## STAFF REPORT

To: University Heights City Council

Item: May 7, 2014 PUD submittal  
1300 Melrose Avenue

Date: May 23, 2014  
To: University Heights City Council  
From: Kent Ralston; Acting Executive Director  
Re: One University Place - Updated Traffic Analysis

**Figure 3**  
Sunset / Melrose AM Peak Hour Left-Turn Lane Warrant (L= % of Left-Turns in Advancing Volume) **Not Warranted**

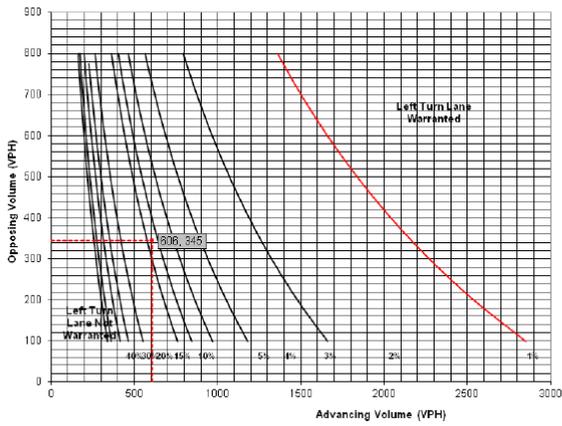
To complete the level-of-service (LOS) analysis at the intersections adjacent to the proposed development, the estimated trip generation figures from Table 1 were added to the existing peak hour traffic data and modeled using Synchro Software. The Sunset/Melrose intersection was modeled with and without a proposed dedicated eastbound left-turn lane to see how the intersection would function under either scenario – this additional analysis was completed as the left-turn warrant at this location is *not* met, but is very close to being met in the PM peak (**Figure 4**).

**Figure 5**  
Sunset / Main Ent. AM Peak Hour Left-Turn Lane Warrant (L= % of Left-Turns in Advancing Volume) **Warranted**

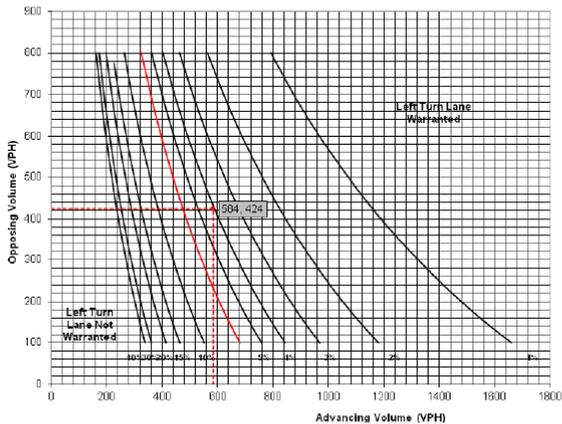
An eastbound dedicated left-turn lane at the Main Entrance is warranted in both the AM and PM peak hours (**Figures 5 & 6**) and therefore the LOS analysis only includes a scenario with a dedicated left-turn lane. The left-turn lane is warranted during the PM peak period even with a 50% reduction in estimated left-turning residential traffic (accounting for 2006-2010 American Community Survey information shows that 43% of University Heights residents used modes other than private vehicles to get to work).

Figure 10 – Peak Hour Signal Warrant & Observed Volumes

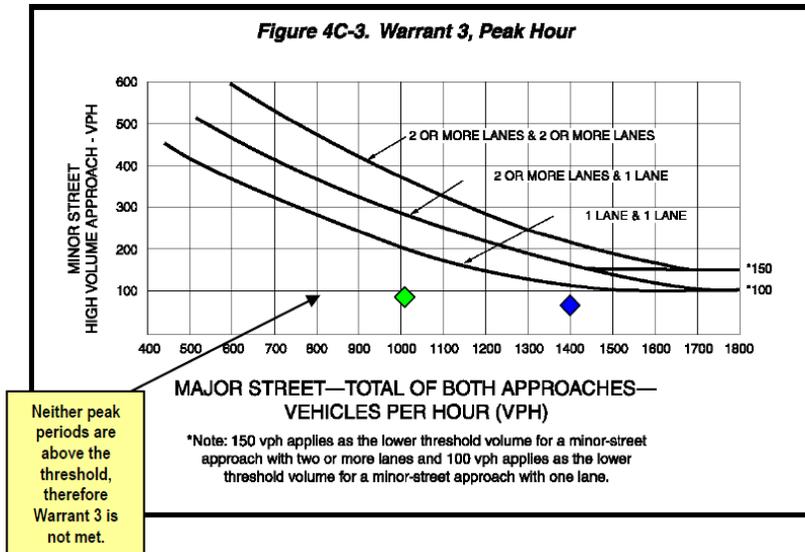
To evaluate whether a traffic signal is warranted at the 'main entrance' intersection we utilize peak hour trip generation figures from Table 1 and apply them to the Manual on Uniform Traffic Control Devices (MUTCD) peak-hour signal Warrant 3. As shown in Figure 9, using our current assumptions, a signal is not warranted in either the AM or PM peak hour. For a traffic signal to become warranted there would need to be an additional (approximate) 105 vehicles exiting in the AM peak hour and approximately 22 additional vehicles exiting the development in the PM peak hour. However, if assumptions on commercial uses should change, a signal may become warranted upon 'build-out' of the development – the signal analysis should be updated at that time.
